2007 - 2013 Cadillac CTS-V: GM TechLink: Low Oil Pressure on V8 Engines

Subject: Low Oil Pressure on V8 Engines

Model and Year: 2007 - 2013 CTS-V, Escalade, Avalanche, Camaro SS, Colorado, Corvette, Express, Silverado, Suburban, Tahoe, Canyon, Sierra, Savana, and Yukon models equipped with a V8 engine (RPOs L20, L77, L94, L96, L99, L9H, LC8, LC9, LH9, LMF, LMG, LY6, LZ1)

Date: August 10, 2015

Fig. 3

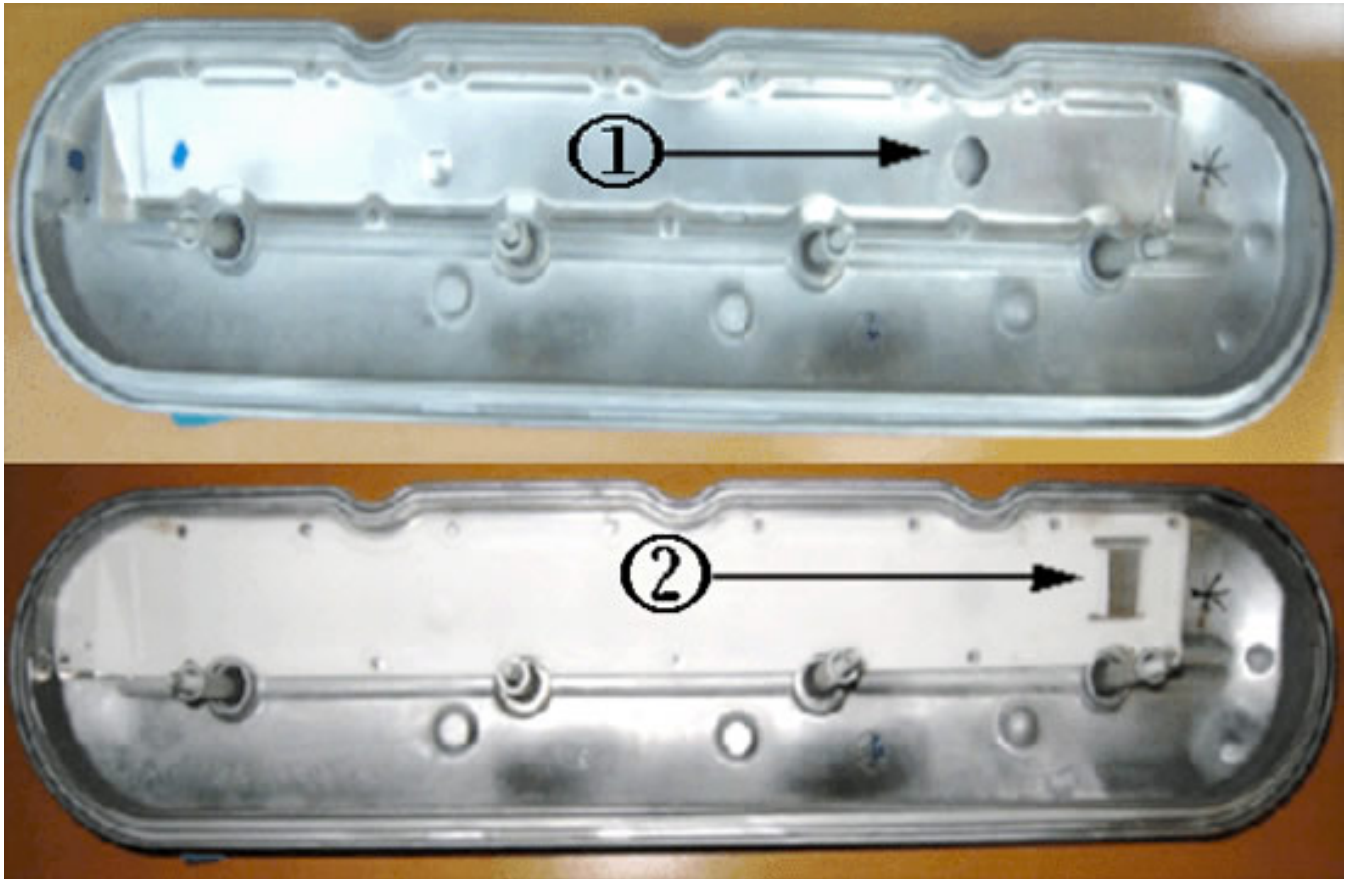
If the engine has been properly repaired and cleaned, inspect the left rocker cover (square baffle) (Fig. 3, #1 – old design; #2 – new design with square baffle) and verify that the baffles can hold water and do not leak. If any leaks are found, clean and seal the edge of the baffle with RTV, if possible, or replace the valve cover. Thoroughly clean and dry the valve cover before installation and/or resealing.
